AFGROW 5.02.5.19 up – Pilatus Review of Relevant Changes on Lug Model

2.1 Detailed Change Description

A crack direction

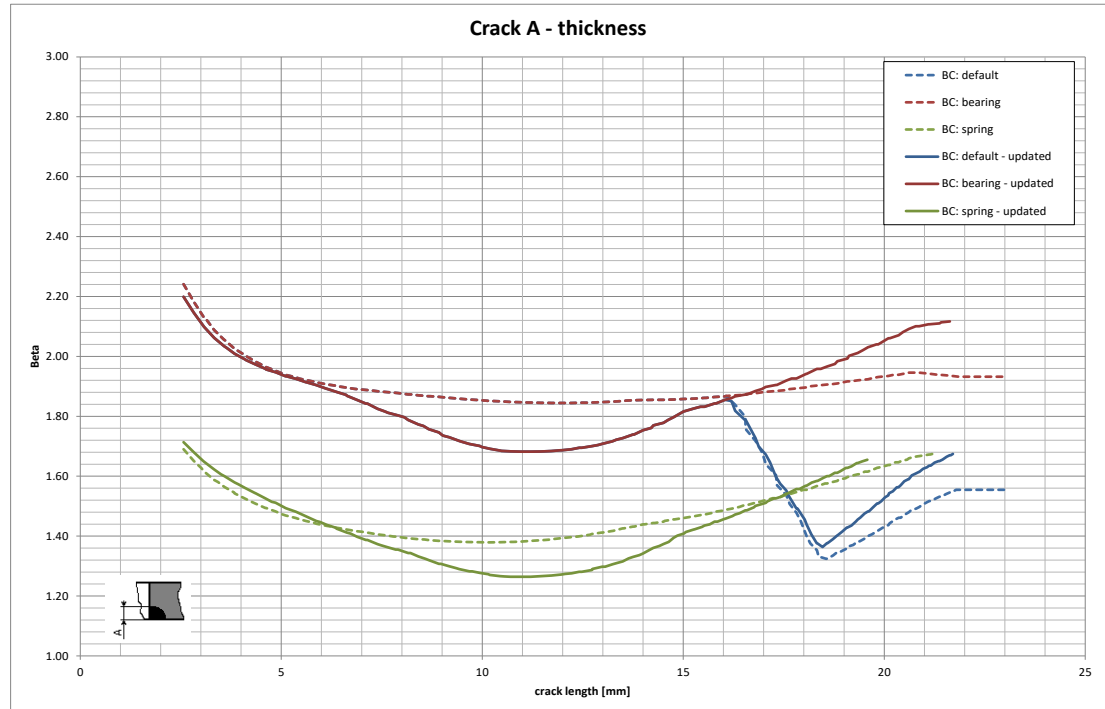
- Significant changes for medium crack sizes
- How can the differences be explained?

C crack direction

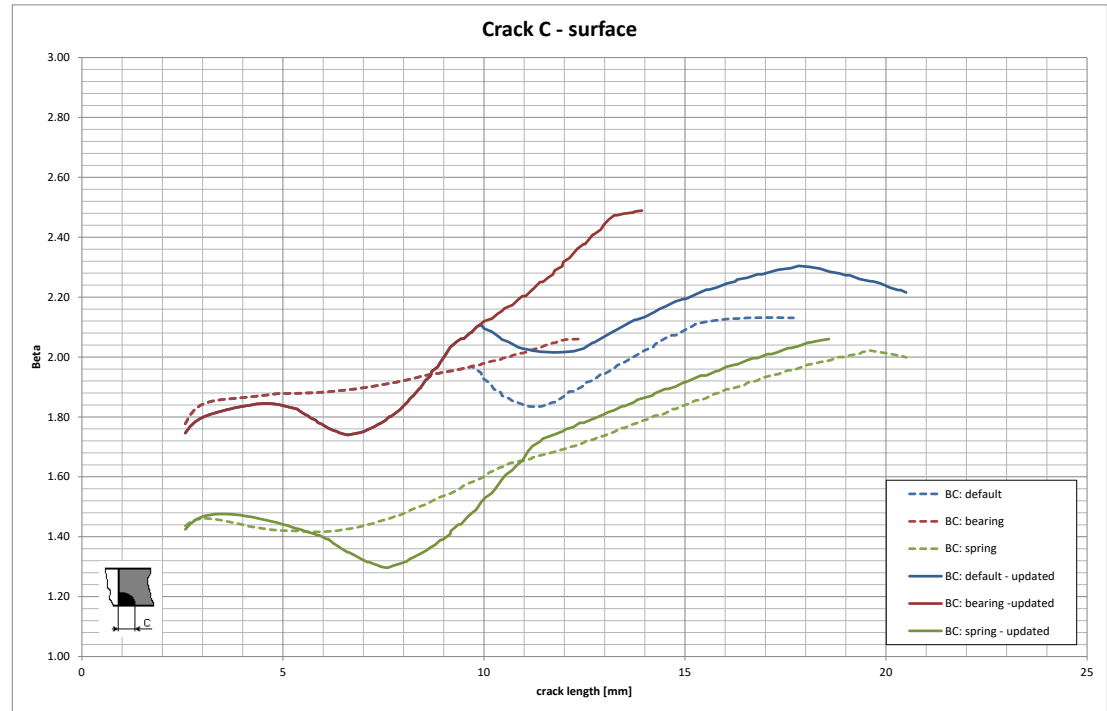
- Significant changes for small to medium crack sizes
- General offset with crossing at medium crack size
- How can the differences be explained?

Lug 4

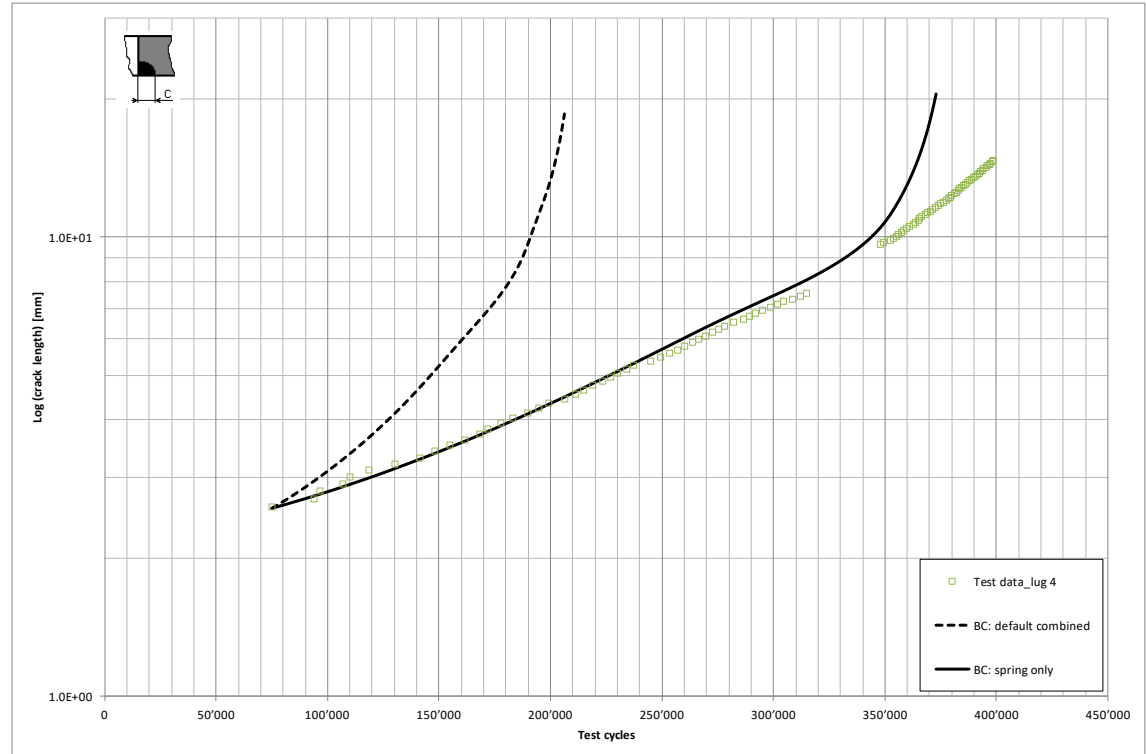
- C Crack Direction
- Conservative lug model for combined condition

Lug 8

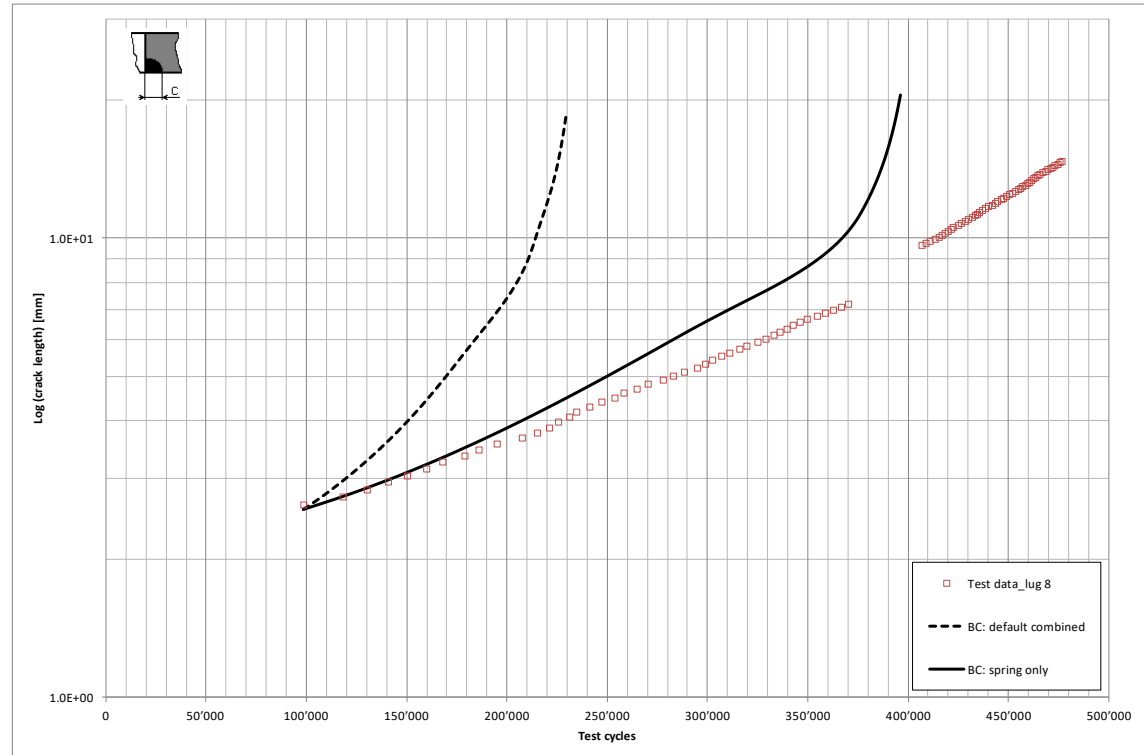
- C Crack Direction
- Conservative lug model for combined condition

5.2 Changes from V5.02.4.18 for Test Lug Geometry

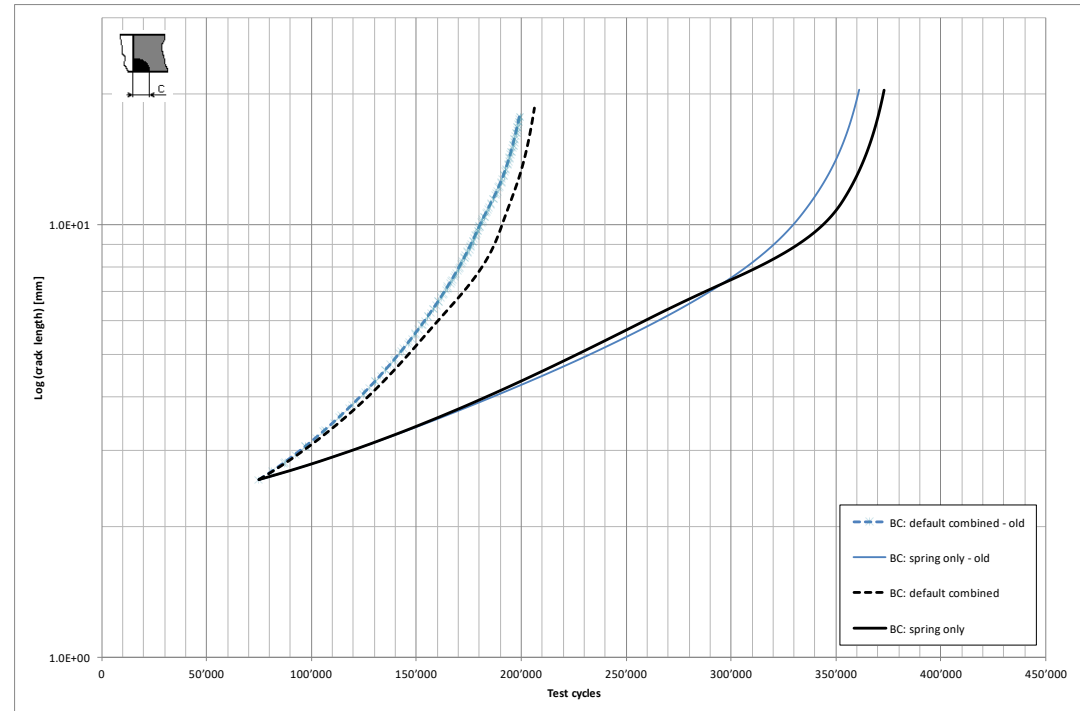
- For combined --:
 - Longer lives for all crack lengths
- For spring -:
 - Similar lives for small to medium crack lengths
 - Longer lives for big cracks
